Bright Future Africa- Vol.2 (Uganda)

Validation Report

Title of report	Bright Future Africa - Vol.2 (Uganda)
ID of report	CC IPL1949/ICR/VAL/GROB/20230710
Client (Project proponent)	GRO Foundation
Criteria for validation	☐ ICR requirement document v.4 ☒ ICR requirement document v.5 ☒ ICR definitions version 2.0 ☒ ICR process requirements version 5.0 ☒ ICR Validation and Verification Specifications v1.0 ☒ ISO 14064-2 ☒ ISO 14064-3 ☒ ISO 14065 ☒ ISO 31000: NPR analysis tool applied for proposed project activity. ☒ Applied methodology, CDM Methodology AR-ACM0003: Afforestation and reforestation of lands except wetlands - v2.0 ¹ ☒ CDM AR-Tool 02: Combined tool to identify the baseline scenario and demonstrate additionality in A/R CDM project activities v1.0
Date of validation	07/08/2023 – 17/07/2024 (Date of on-site inspection to FVR Preparation)
Version number of this validation report	6
Date of version	29/01/2025
Prepared by	Carbon Check (India) Private Limited (CC IPL)

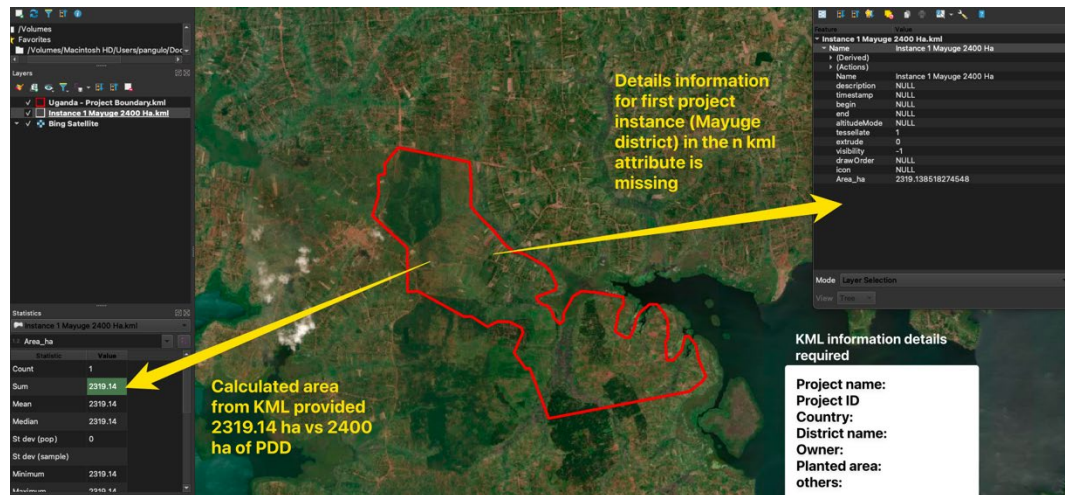
CAR	05	Section no.	2.3 of ICR PDD	Date: 24/09/2023
Description of CAR				
As per section 3.4.2 of the ICR requirement v5.0,				
<i>"For project activities involving CDR, a crediting period of a maximum of 15 years or a conservative estimate of the technical lifetime of the installed technologies or implemented measures and associated impacts."</i>				
However, in section 2.3 of ICR-PDD, it has been mentioned that the total length of crediting is 50 years.				
PP shall correct the crediting period in compliance with section 3.4.2 of ICR requirements v5.0.				
Project participant response				Date: 12/10/2023
As an afforestation CDR project, we decide our crediting period to be 45 years as we consider this as s "conservative estimate of the technical lifetime of the installed technologies or implemented measures and associated impacts". We rewrote the text in section 2.3 of the ICR-PDD to be in compliance with section 3.4.2 of ICR requirements v5.0.

Documentation provided by project participant				
VVB assessment				Date: 16-02-2024
The revised crediting period in section 2.3 of the ICR-PDD has been set to 60 years, however, as per section 3.4.2 of ICR Requirements v5.0,				
<i>"For project activities involving CDR, a crediting period of a maximum of 15 years or a conservative estimate of the technical lifetime of the installed technologies or implemented measures and associated impacts."</i>				
PP is requested to revise the ICR-PDD with the correct crediting period in compliance with above-mentioned requirement.				
CAR is still open				
Project participant response				Date: 25.03.2024
After a discussion with the head of ICR – Gudmundur, we set our crediting period to 45 years (15 years + 2 renewals every 15 years), the PDD is revised with the correct crediting period in compliance with the requirements mentioned above				
Documentation provided by project participant

Based on the review of the revised PDD and ex-ante carbon calculation sheet, VVB confirms that the crediting period has been specified as 45 years (15 years + 2 renewals), which is deemed appropriate and in compliance with section 3.4.2 of ICR Requirements v5.0.

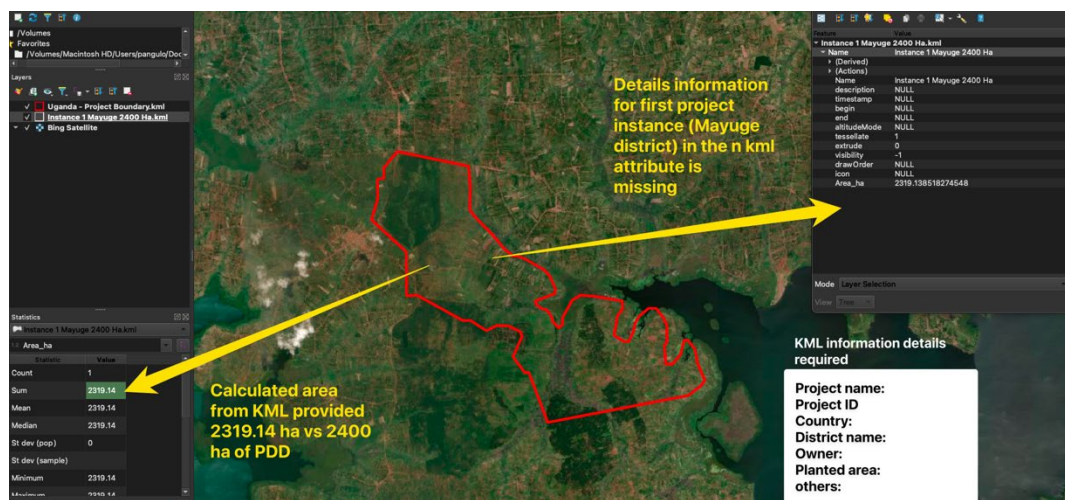
CAR	12	Section no.	Date: 24/09/2023
Description of CAR			
As per section 4.2 of the ICR requirement v5.0, PP shall provide the following maps and shapefiles

Downloadable KML files available in “CAR 06” folder of the Database
